Public Comments Report: Formal Actions on all Public Comments and Committee Comments

November 30, 2020

Prior to the Public Comments phase of development, the Consensus Committee took action on Proposed Changes submitted by the Public and on Committee Proposals. This work on the development of the 2020 edition of ANSI Z765 Square Footage: Method for Calculating is reported in the Public Proposals Report (PPR) and the First Draft Standard that were released to the public on February 7, 2020. Both documents and all other relevant records, including this report, are posted at www.homeinnovation.com/Z765.

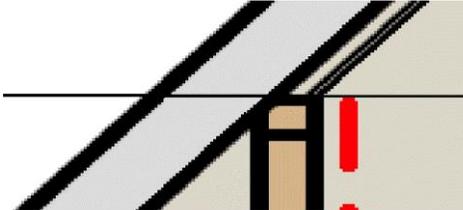
PC 40 – Section 3.6 Ceiling Height Requirements, Figure 5		Final Formal Action: Disapprove
Submitter:	Bryan Reynolds	
Requested Action:	Revise as follows	
Proposed Change:	Section 3. Ceiling Height - This proposed change will create more confusion than clarity in the valuation profession and for other users. As a national instructor, I witness many students are already confused

with this section and this attempt for clarity will fail. I strongly recommend this change not be made to this section.										
Reason:	Negative Ballot Comment										
Substantiating Documents:											
CC Action:	Disapprove										
Modification of Comment:											
CC Reason:	In favor of action on PC 41.										
Ballot II Results on Committee Action:

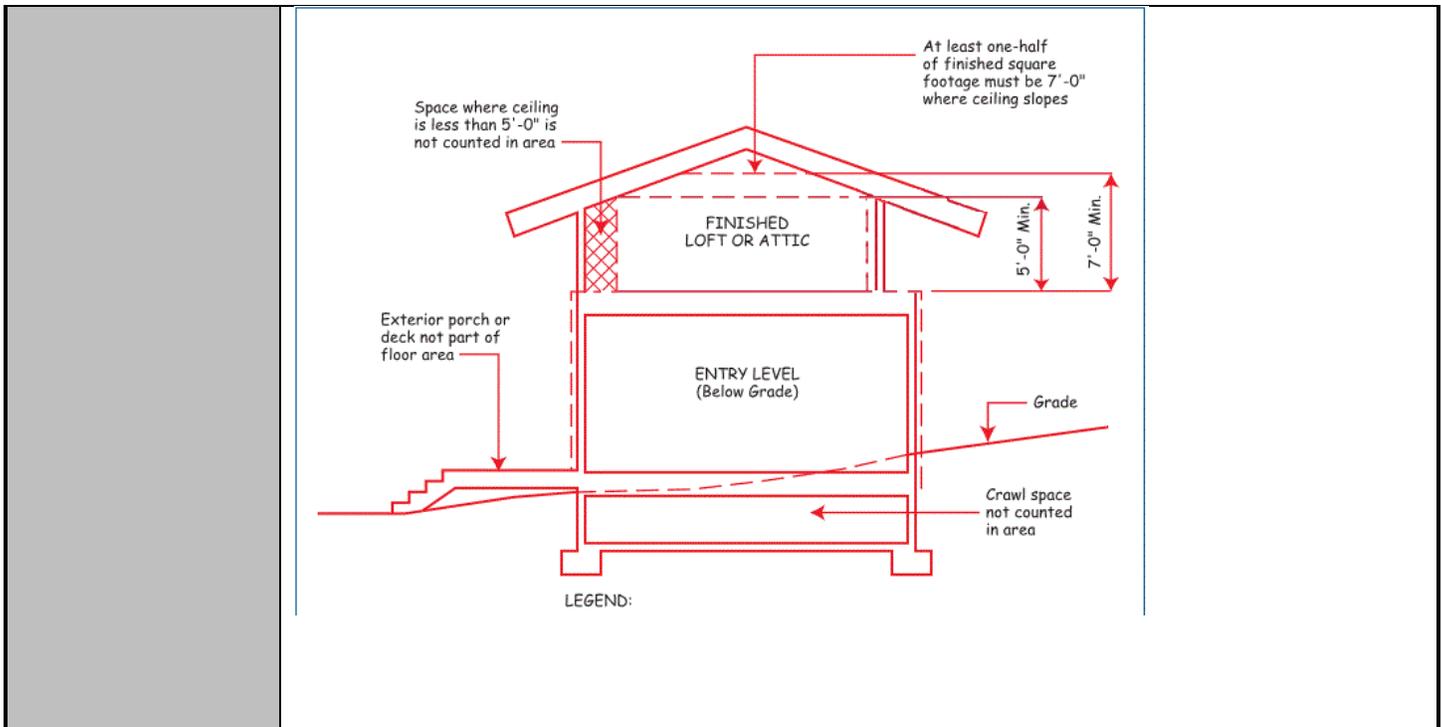
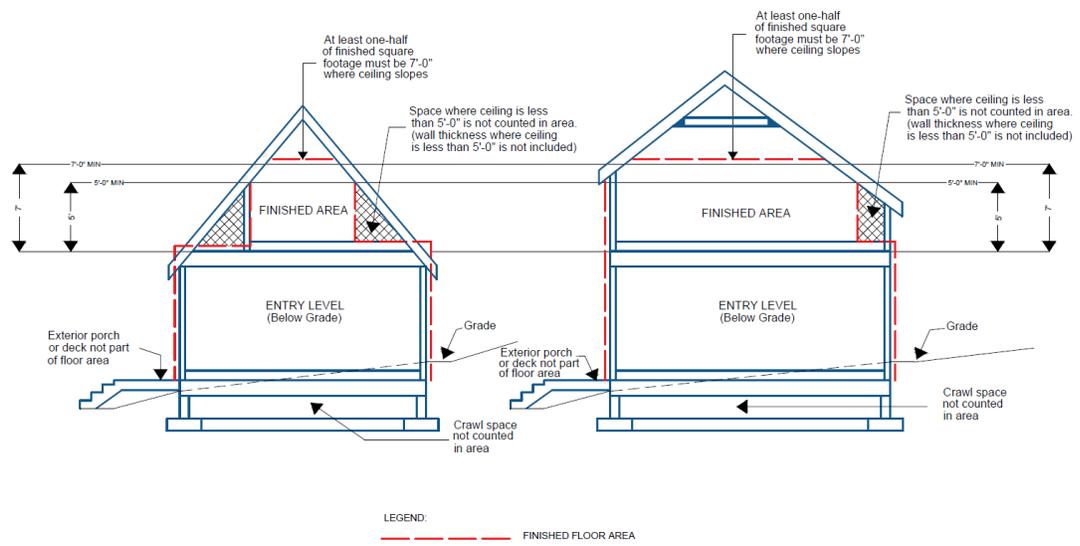
PC 41 – Section 3.6 Ceiling Height Requirements, Figure 5		Final Formal Action: Approve as Modified
Submitter:	Darwin Ernst	
Requested Action:	Revise as follows	
Reason:	Negative Ballot Comment	
Proposed Change:	 <p>The drawing I provided in my ballot response is more clear than the one that was provided in the ballot, but I would offer an updated version of this edited figure/image (see attached) to members based on my opinion that the upper floor measurement of all sloped ceiling heights should be restricted to the point of the sloped ceiling at the 5' mark above the floor, regardless of whether there is an exterior wall, pony wall, or any other type of wall beyond the point where the upper floor's ceiling height is 5' above the floor, so there is consistency in the upper floor measurement by all users of the standards.</p> <p>The proposed modification (see below) in item 11 to include the width of an exterior wall on upper floors beyond where the ceiling height reaches a point on the slope of an upper floor ceiling at a point 5' above the floor will be confusing to many potential users, so I am hopeful that we can discuss this motion further.</p>

Reason: Negative Ballot Comment

Modification of Comment: Replace Figure 5 with the following. See Appendix for Larger Figure.

CC Reason: CC agreed with the submitter that the figure needed edits and was unclear. Modifications kept the figure simple but added needed clarity.
